Addendum Number: 03

Addendum Issue Date: April 28, 2025

Project Name: Robinson Washington Elementary
Renovation & Addition

Project Number: 02401781.001

ENLARGED VENTILATION FLOOR PLAN - AREA B

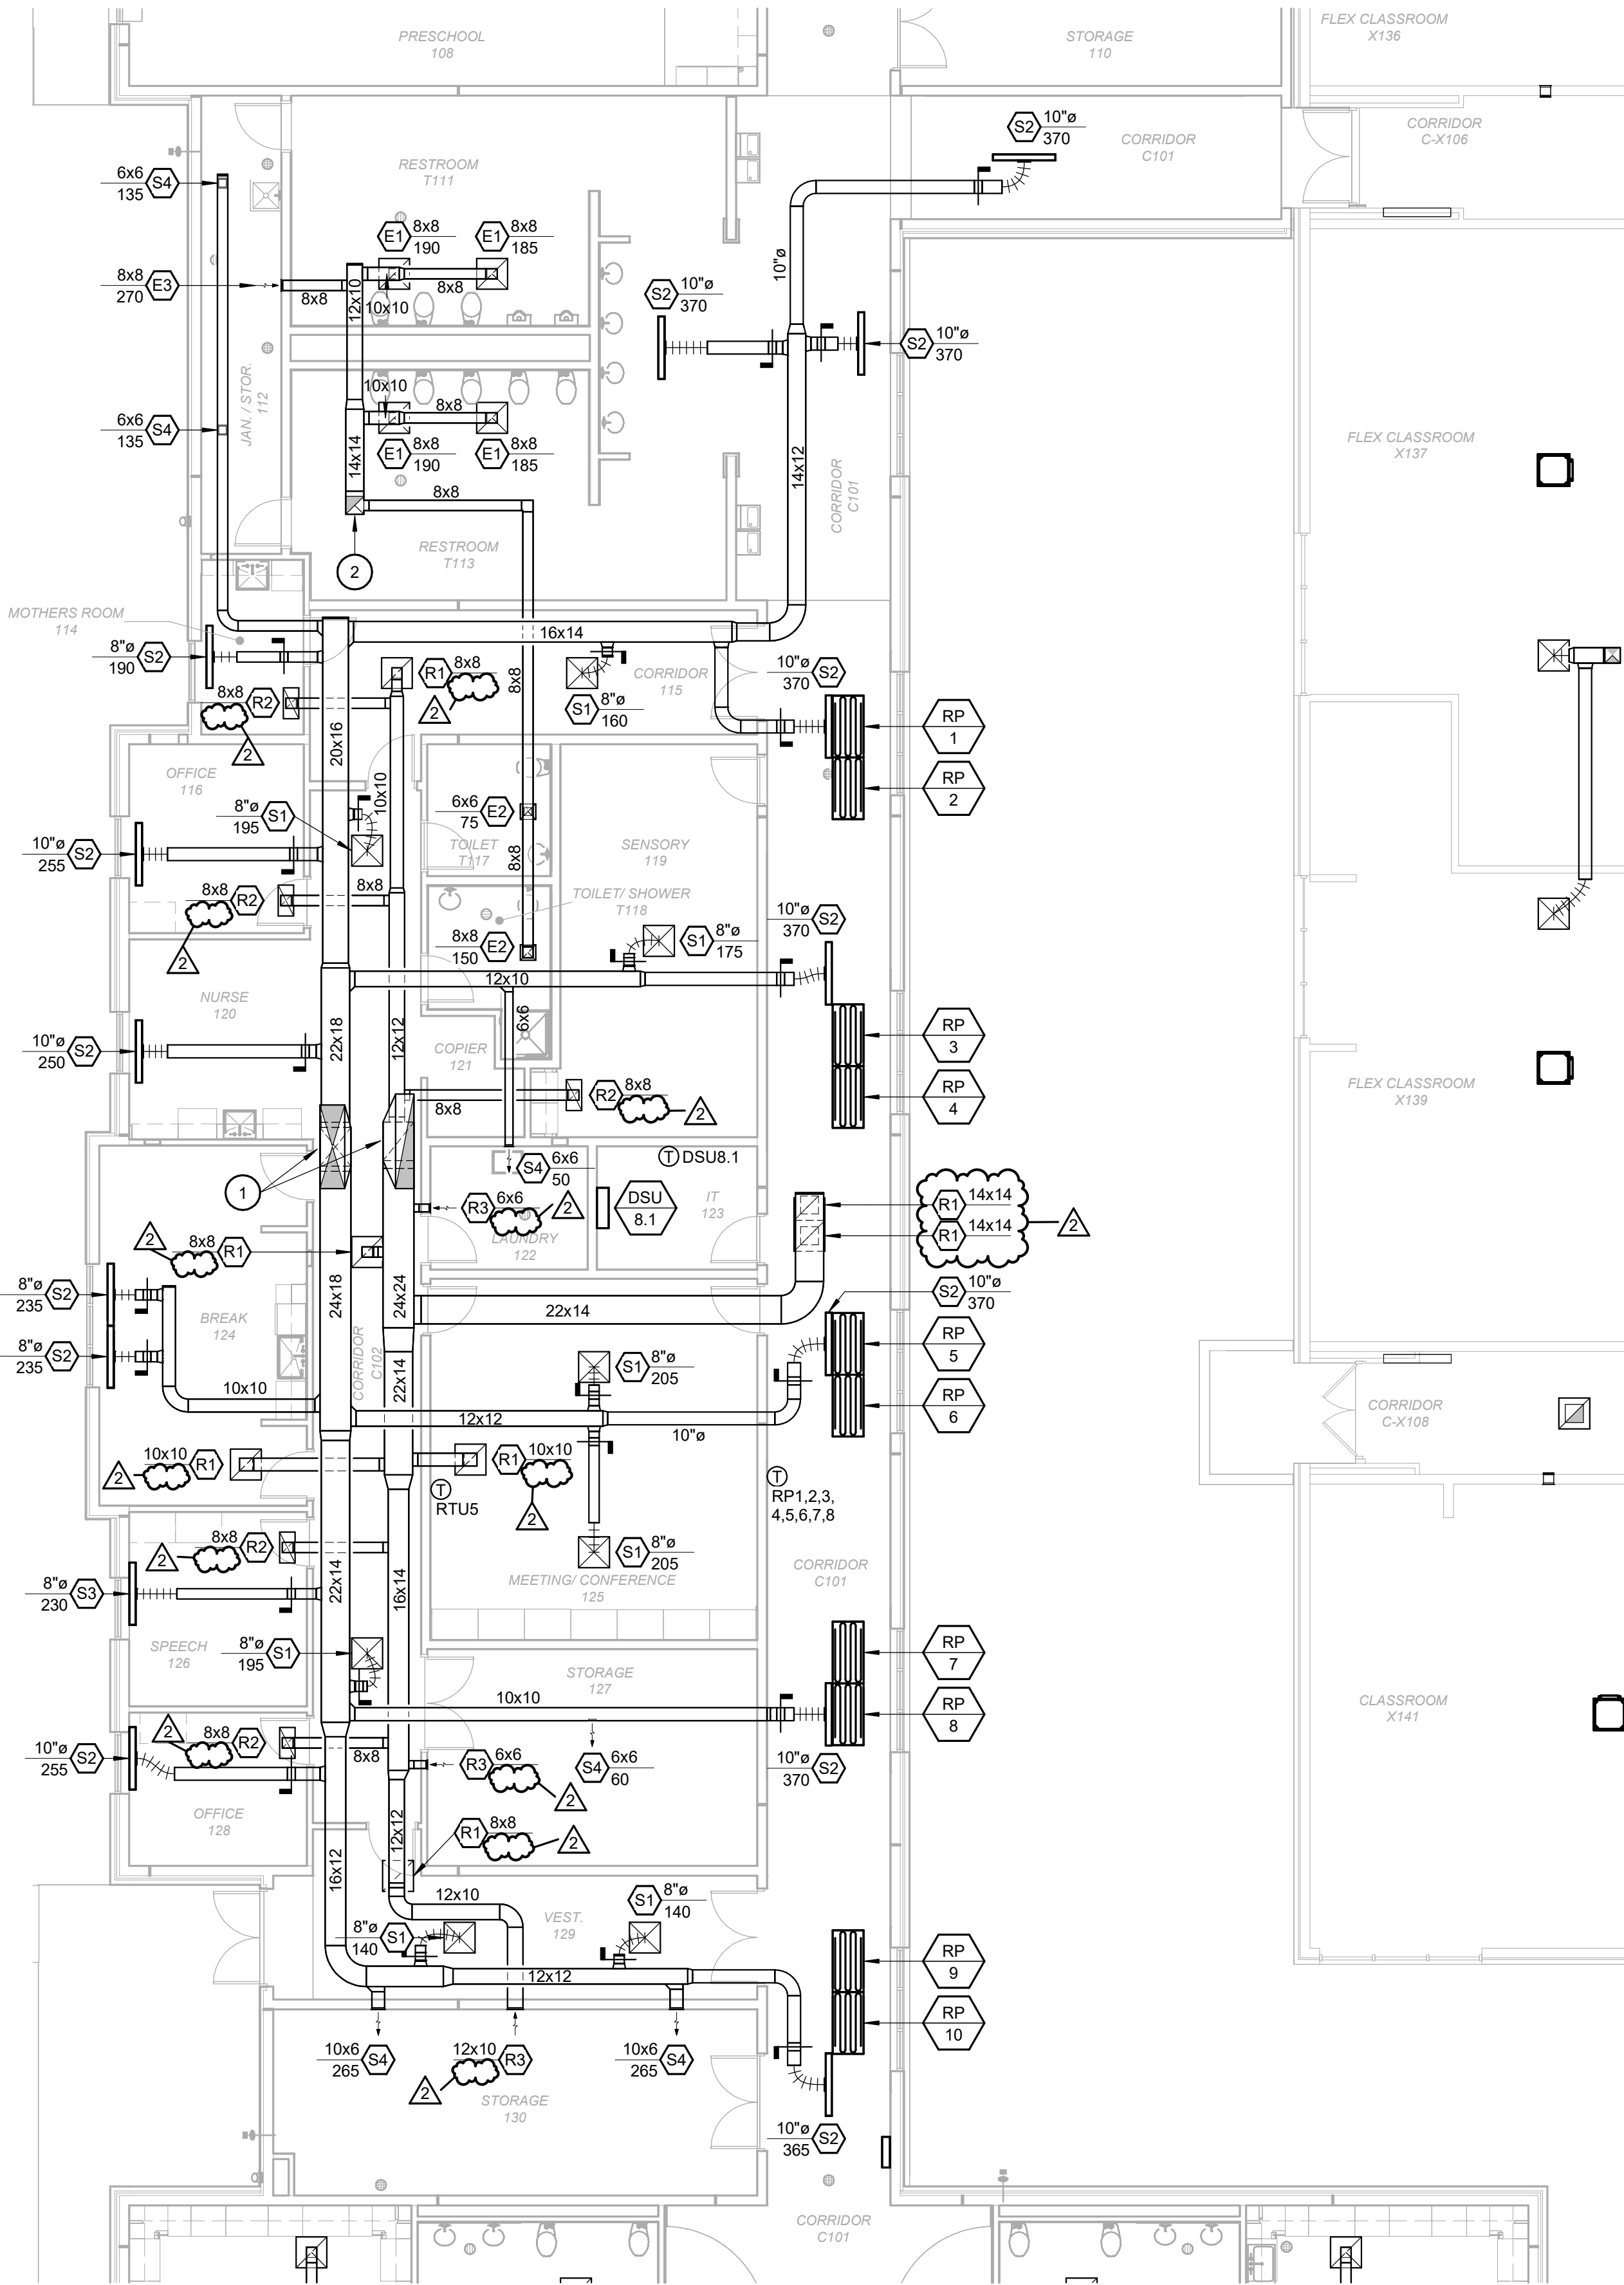
- a. REVISE ductwork.
 - b. ADD keynote #3.
 - c. REMOVE cfm values on air device tags for return air devices that do not require volume dampers.
7. M1.1B – ENLARGED VENTILATION FLOOR PLAN – AREA B

- a. REMOVE cfm values on air device tags for return air devices that do not require volume dampers.
8. M1.1D – ENLARGED VENTILATION FLOOR PLAN – AREA D

ENLARGED VENTILATION FLOOR PLAN - AREA D

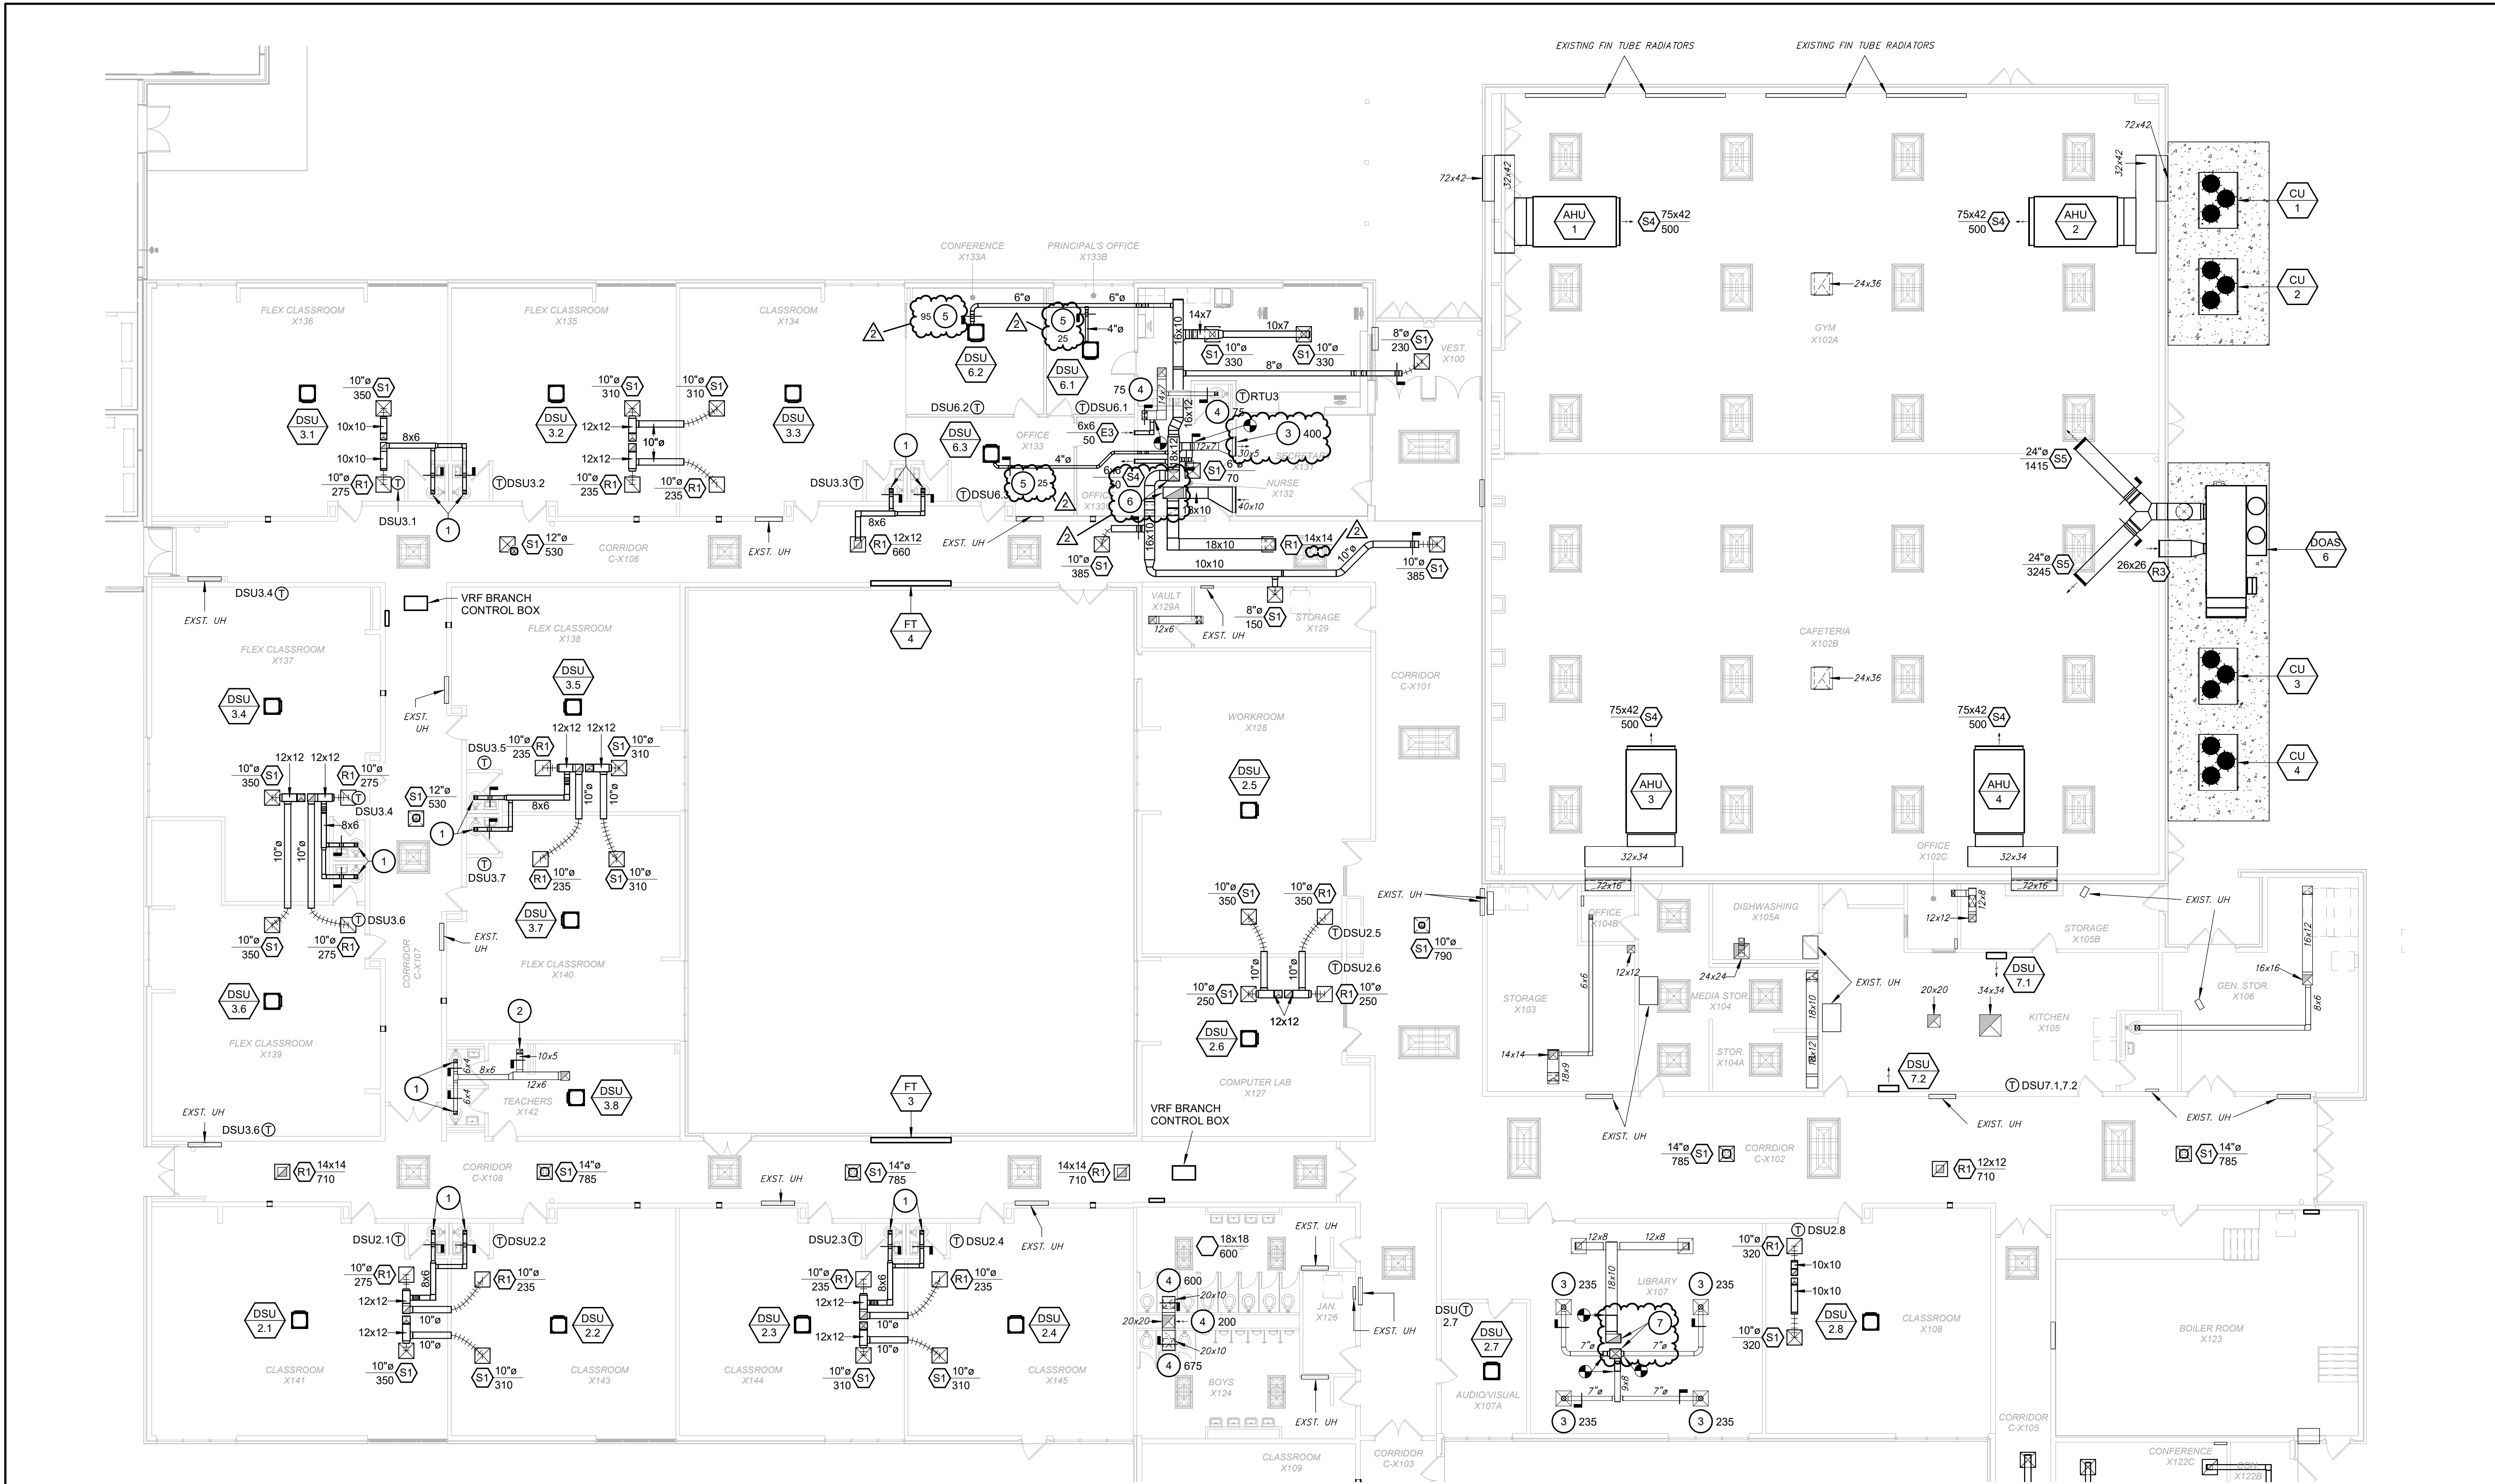
- a. REMOVE cfm values on air device tags for return air devices that do not require volume dampers.
 - b. ADD keynote #3 to existing wall grille in Secretary X131.

- c. ADD keynotes #5, #6, and #7.
9. M1.1E – ENLARGED VENTILATION FLOOR PLAN – AREA E
 - a. REMOVE cfm values on air device tags for return air devices that do not require volume dampers.

ENLARGED VENTILATION FLOOR PLAN - AREA E

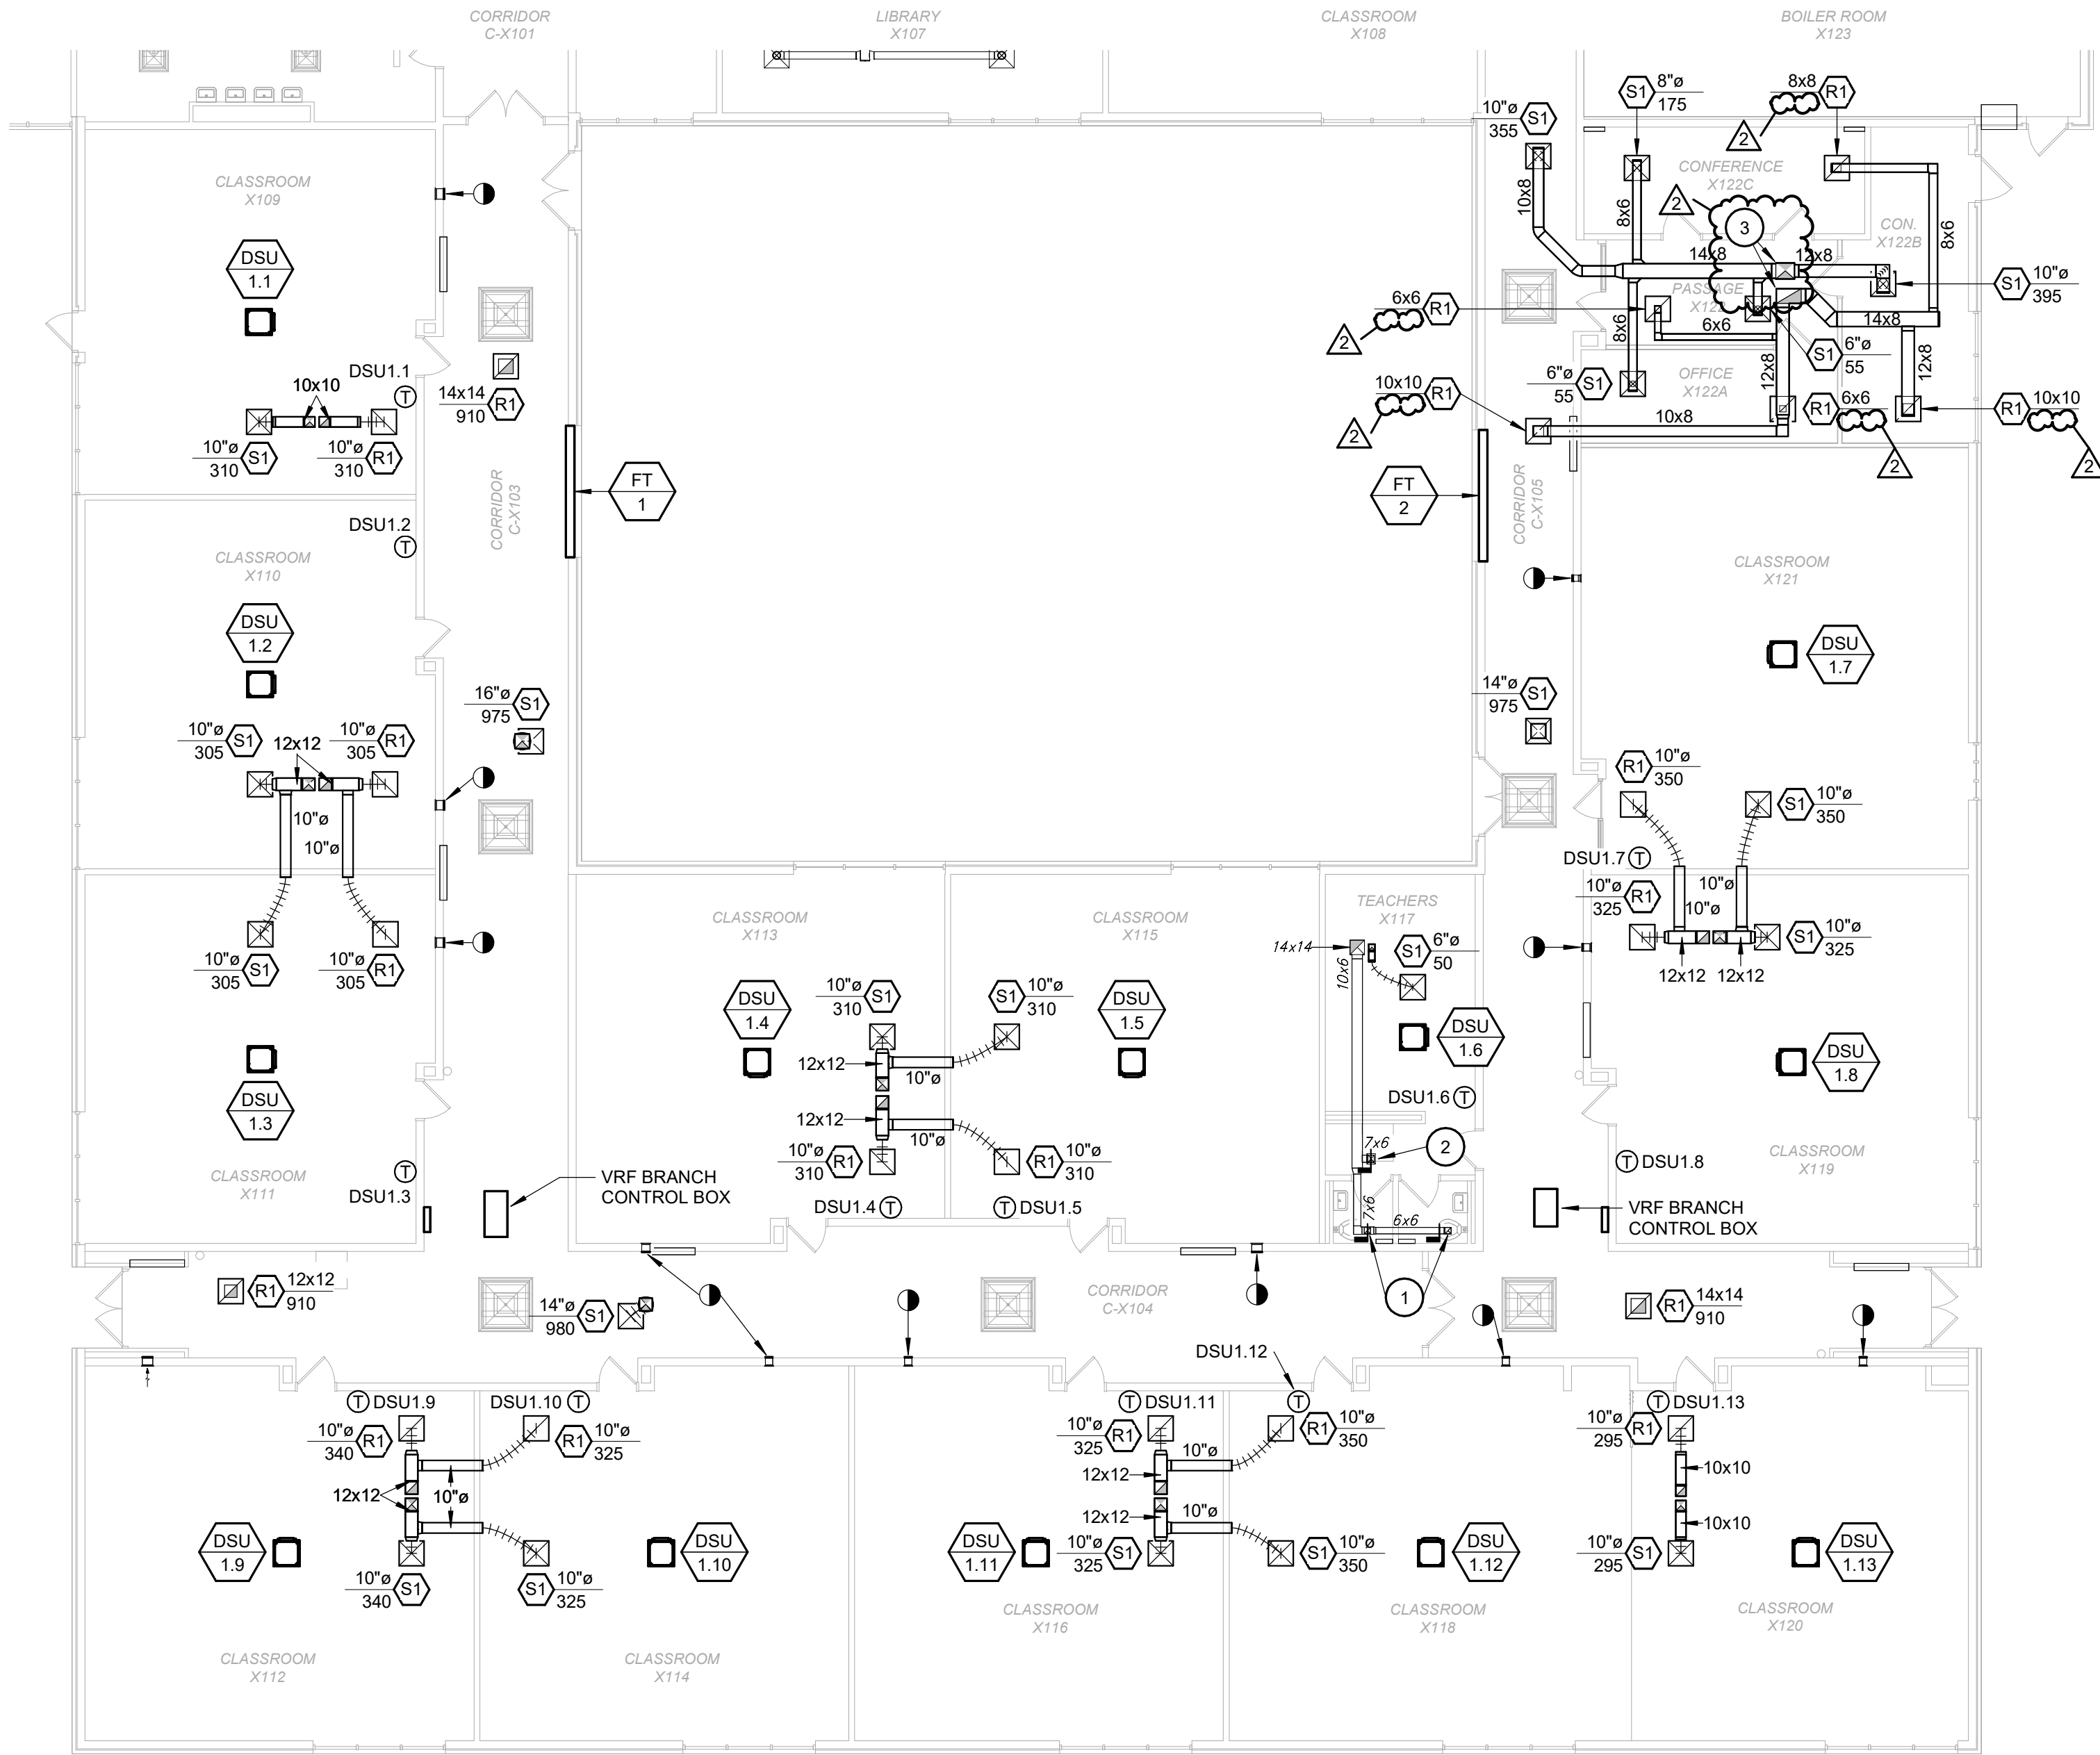
- b. ADD keynote #3.
10. M1.4 – OVERALL ROOF MECHANICAL PLAN
 - a. ADD keynote #5.
11. M2.1A – ENLARGED MECHANICAL PIPING FLOOR PLAN – AREA A
 - a. ADD VRF System control panel locations.

- 1 RECONNECT NEW DUCTWORK TO EXISTING EXHAUST DIFFUSERS. INSTALL VOLUME DAMPERS IF NONE ARE PRESENT. BALANCE TO 75 CFM EACH.
- 2 RECONNECT NEW DUCTWORK TO EXISTING EXHAUST DIFFUSERS. INSTALL VOLUME DAMPERS IF NONE ARE PRESENT. BALANCE TO 75 CFM EACH.
- 3 18x15 INCH SUPPLY AIR AND 24x14 INCH RETURN AIR DUCTS UP TO ROOFTOP UNIT RTU1.
